**RE: SUBMISSION TO SSD-82548708, RESIDENTIAL FLAT BUILDING WITH INFILL - AFFORDABLE HOUSING - 24,26 &28 Middle Harbour Road**

**Ku-ring-gai Council's objection/submission to SSD-82548708 for Residential Flat Building with Infill - Affordable Housing at No. 24,26 & 28 Middle Harbour Road**

**Figure 2:** No. 19 Russell Street, Lindfield, (circled) in front of proposed development [marked on DA “eye of the Sun”].

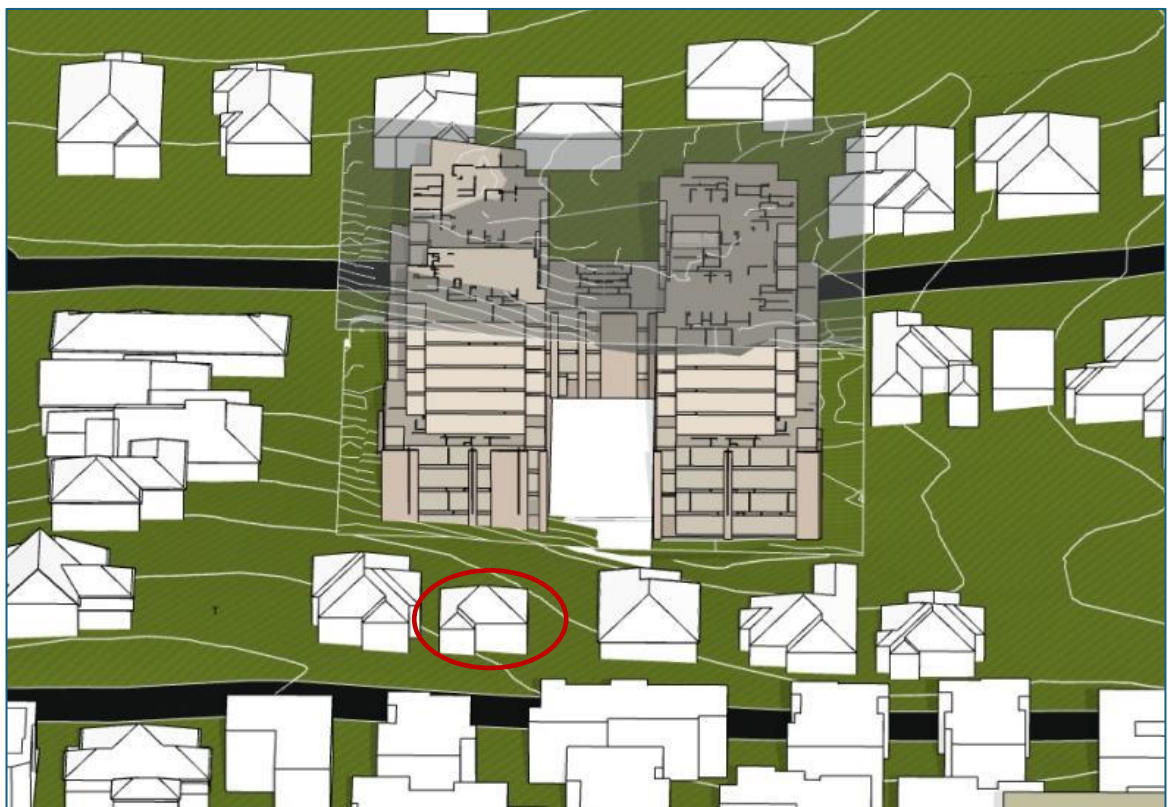
- Insufficient Heritage Analysis

- The submitted heritage documentation, including the Visual Impact Assessment, is inadequate.
- The Visual Analysis does not provide views from Russell Street to the heritage item with the proposed development in the background. As a result, the impact on the heritage item's setting and key views cannot be properly assessed.
- The analysis also omits reciprocal views from the heritage item towards the proposed development, which is essential for evaluating visual intrusion and compliance with KDCP requirements.
- The massing context has been inaccurately represented, relying on a hypothetical future development of adjacent sites under SEPP Housing provisions (Figure 4). A more realistic scenario based on the TOD alternative development potential of the surrounding sites, rather than presuming maximum uplift in accordance with Chapter 5 of SEPP Housing should be considered.
